RE: Better Brite RI/FS, DePere, Wisconsin

SAMPLING AND ANALYSIS PLAN REMEDIAL INVESTIGATION/ FEASIBILITY STUDY BETTER BRITE PLATING, INC. DE PERE, WISCONSIN

Re: Modified Scope for Better Brite RI/FS

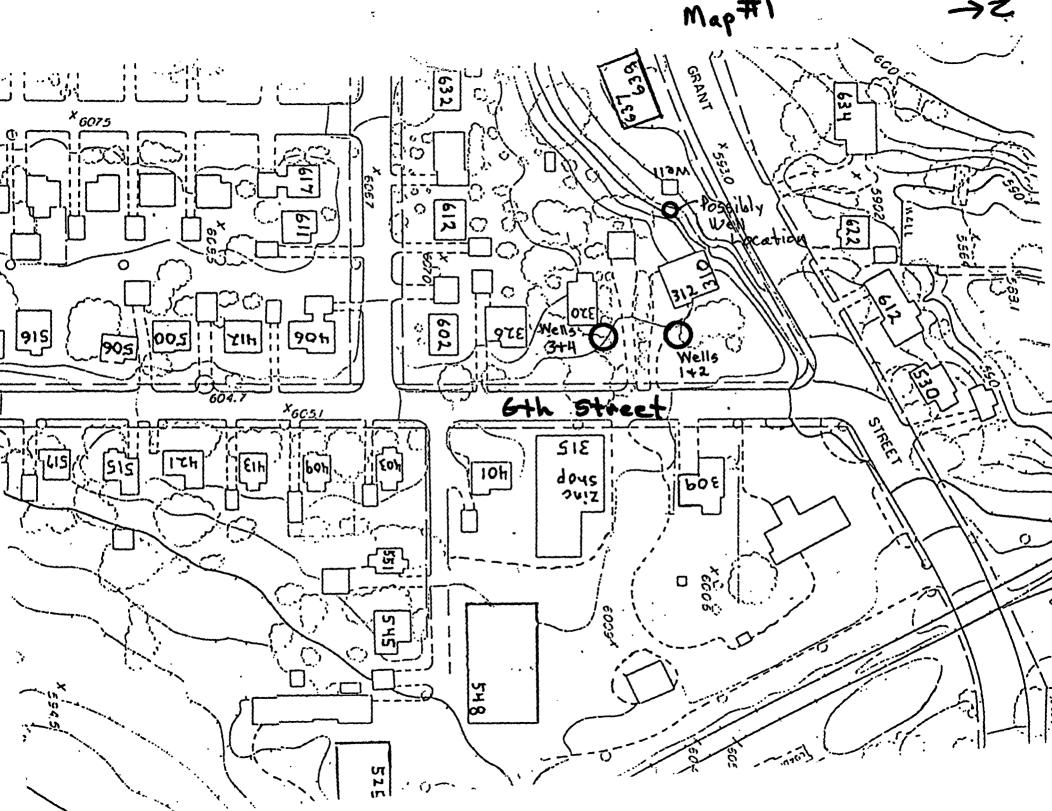
- This would provide unrestricted access from 6th Street around the fenced in area.

- A removable panel (or gate) should be installed along this side to provide access to the enclosed area west of the berm.

- Sufficient room should be maintained within the fence to facilitate transferring water from the Zinc Shop and drum removal.

- Sufficient room along the railroad tracks should also be provided for the railroad company.
